TECHNICAL SPECIFICATIONS

DUANE ARNOLD ENERGY CENTER
IES UTILITIES INC.
TECHNICAL SPECIFICATIONS

By letter dated November 30, 1995, IES Utilities Inc. submitted a request for revision of the Technical Specifications (TS) for the Duane Arnold Energy Center (DAEC). The proposed amendment would implement the Boiling Water Reactor Owner's Group (BWROG) Option I-D long term thermal-hydraulic instability solution and eliminate the specifications and surveillance requirements based on the older General Electric (GE) SIL 380 Rev. 1 recommendations. In addition, the proposed amendment would specify that the reactor be scrammed during operation in natural circulation and that an idle recirculation pump not be restarted while in natural circulation. Natural circulation would be more clearly defined. Finally, the proposed amendment would eliminate certain requirements related to monitoring core plate differential pressure noise during single recirculation loop operation

THERMAL POWER VS CORE FLOW LIMITS
FOR THERMAL HYDRAULIC STABILITY
SURVEILLANCE
FIGURE 3.3-1

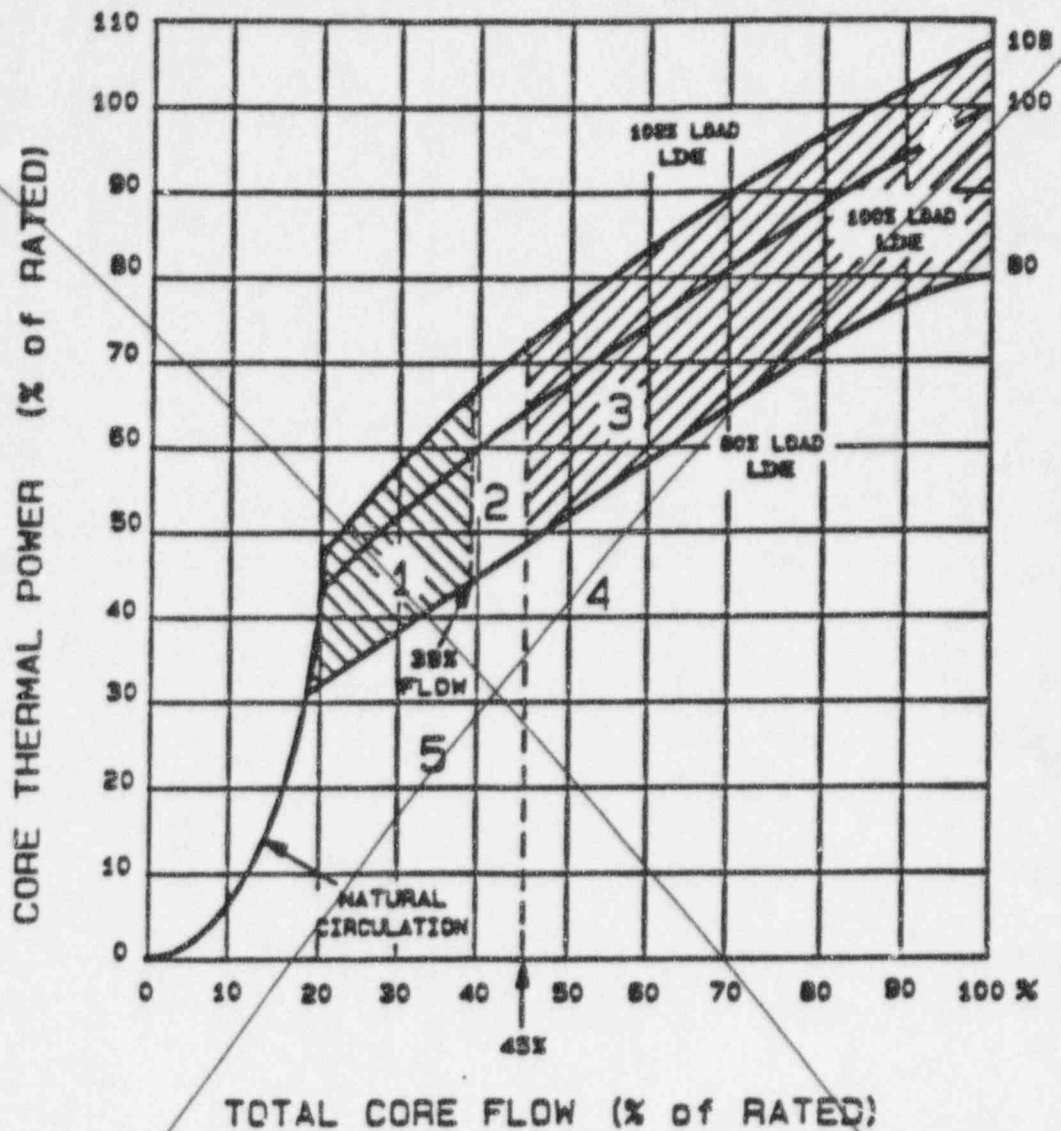
APRM and/or LPRM oscillations in excess of those specified in section 3.3.F could be an indication that a condition of thermal hydraulic instability exists and that appropriate remedial action should be taken. Instability can occur in two loop or single loop operation. Therefore, instability monitoring is required in certain regions of Figure 3.3-1.

Above 45% of rated core flow in SLO there is the potential to set up high flow-induced noise in the core. Thus, surveillance of core plate AP noise is required in this region of Figure 3.3-1 to alert the operators to take appropriate remedial action if such a condition exists.

- Region 1: Two Loop Surv. Region, SLO Prohibited Region
- requires APRM/LPRM noise monitoring
- Region 2: Two Loop & SLO Surv. Region
- requires APRM/LPRM noise monitoring
- Region 3: SLO Surv. Region
- requires APRM/LPRM & Core Plate D/P noise monitoring
- Region 4: Extended SLO Surv. Region
- requires Core Plate D/P noise monitoring
- Region 5: Unrestricted Two Loop & SLO Region

Operation in the Exclusion Region of the power/flow map described in the Core Operating Limits Report is not permitted. If entry into this region occurs, immediately insert control rods or increase core flow to exit the region.

The reactor design criteria is such that thermal hydraulic oscillations are prevented or can be readily detected and suppressed without exceeding specified fuel design limits. To minimize the likelihood of an instability, a power/flow exclusion region to be avoided during normal operation is calculated using the approved methodology as stated in Specification 6.11.2.a.5. Since the exclusion region may change each fuel cycle, the limits are contained in the Core Operating Limits Report. Specific directions are provided to avoid operation in this region and to immediately exit upon an entry. Entries into the exclusion region are not part of normal operation. An entry may occur as a result of an abnormal event, such as a single recirculation pump trip. In these events, operation in the exclusion region may be needed to prevent equipment damage, but actual time spent inside the exclusion region is minimized. Though each operator action can prevent the occurrence and protect the reactor from an instability, the APRM flow-biased scram function is designed to suppress global oscillations, the most likely mode of oscillation, prior to exceeding the fuel safety limit. While global oscillations are the most likely mode, protection from out-of-phase oscillations are provided through avoidance of the exclusion region and administrative controls on reactor conditions which are primary factors affecting reactor stability.
